Subject: Safety Inspection of Dams in North Carolina
Per NCUC Order, Docket No.: E-100, Sub. 23
Dan River Steam Station Ash Dikes
File Nos.: SSS-0503, GAH-0202, SSS-0502

DAN RIVER STEAM STATION
ASH BASIN DIKES
ROCKINGHAM COUNTY, NORTH CAROLINA
LETCo. Job No. CHW 5475

SECOND FIVE-YEAR INDEPENDENT CONSULTANT INSPECTION
AS REQUIRED BY
NORTH CAROLINA UTILITIES COMMISSION

Subject: Five-Year Independent Consultant Inspection
Dan River Steam Station
Ash Basin Dikes
Rockingham County, North Carolina
Per North Carolina Utilities Commission
LETCo. Job No. CHW 5475

PHOTO 4-14 WET TOE AREA AT WEST END OF PRIMARY BASIN

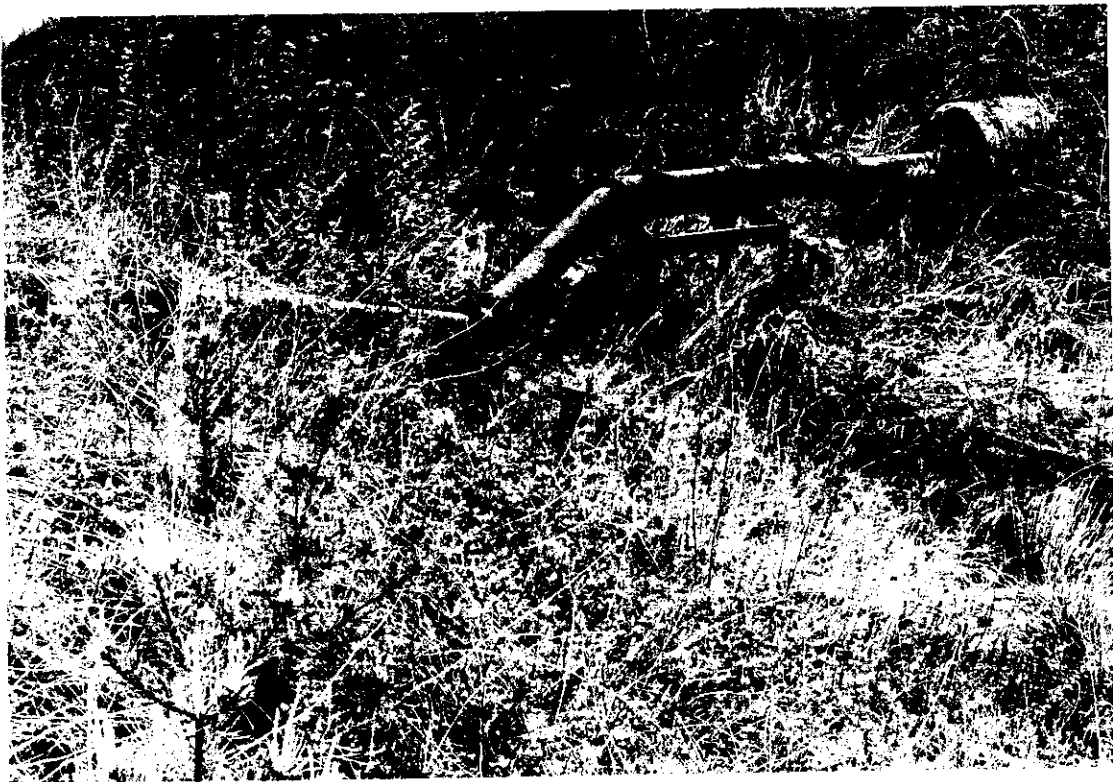
The wet area located at the base of the original (1956) dike at the west end of the primary basin, where the ash sluice and waste water sump lines cross over to the basin, still exists in much the same way it appeared in the 1981 inspection; a view of part of this area is shown in Photo 4-14. A hole caused

PHOTO 4-15 HOLE CAUSED BY SEEPAGE EROSION AT TOE OF DIKE IN WET AREA
SHOWN IN PHOTO 4-14

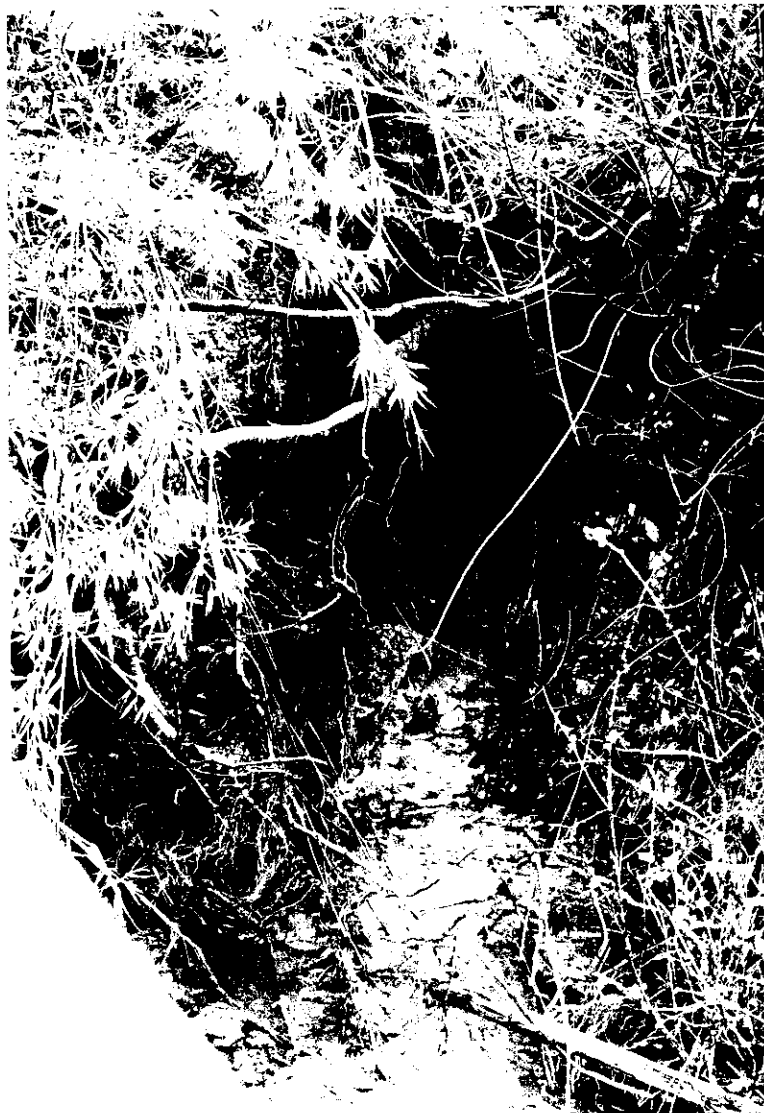
by seepage erosion was observed at the base of the dike next to the ash line shown in Photo 4-14. A view of this hole and orange colored seepage emerging from it is shown in Photo 4-15; the hole was probed and found to extend approximately 18 inches horizontally into the toe of the dike. The erosion (piping) did not appear to be active at the time of inspection, based on the lack of soil fines in the seepage.
